LEVEE STABILITY

Three Rivers Levee Improvement Authority

Levee Repairs Project Phases 1, 2 and 4

Technical Memo

TYPICAL FAILURE SURFACE
NTS

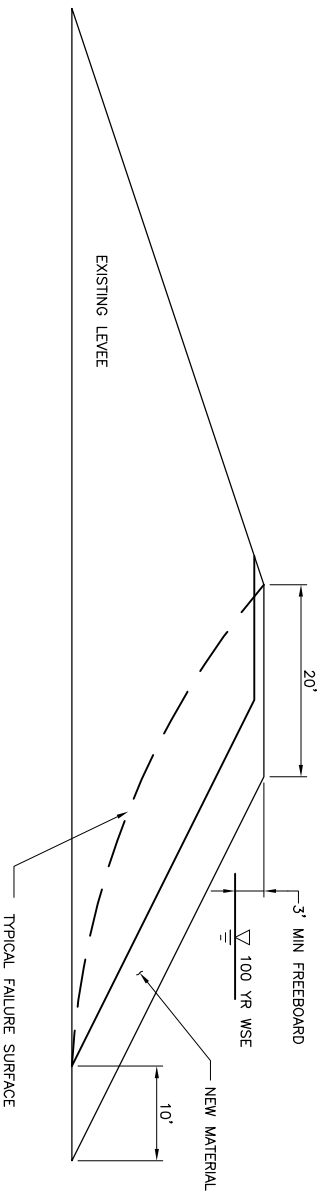
In the vast majority of the cases the new fill was placed in a narrow layer (2 to 3 feet wide) on the waterside of the levee and/or on the crown of the levee (above the 100-year water surface elevation). In these cases, neither the strength nor permeability of the placed material is critical to the overall performance of the levee embankment. This is illustrated in the attached Figure 1 which shows the relationship of the placed fill to a typical critical failure surface and the 100-year water surface elevation.
